STATE OF DELAWARE
EXECUTIVE DEPARTMENT
OFFICE OF STATE PLANNING COORDINATION

May 18, 2015

RE: PLUS review 2015-04-04, Cape Henlopen School District

Thank you for meeting with State agency planners on April 22, 2015 to discuss the proposed plans for the Cape Henlopen Elementary School. According to the information received, you are seeking site plan review for the construction of a 79,990 sq. ft. elementary school in Sussex County.

Figure 1: NRCS soil survey mapping update

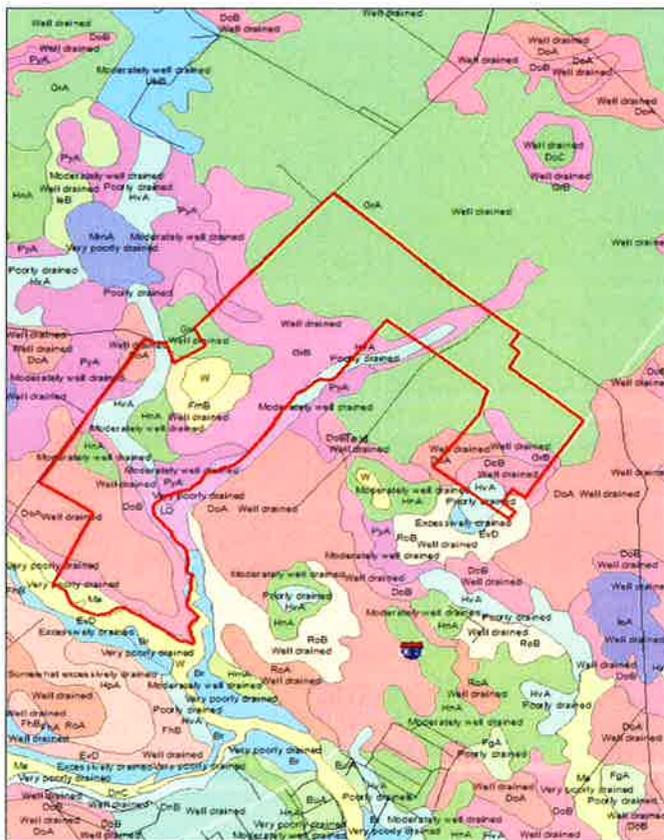
- Based on soils survey mapping update, the soil mapping units with the most limitations for development in the immediate vicinity of the proposed project is Hurlock (HvA). Hurlock is a poorly-drained wetland associated (hydric) soil that has severe limitations for development (considered unsuitable for development; Figure 1).
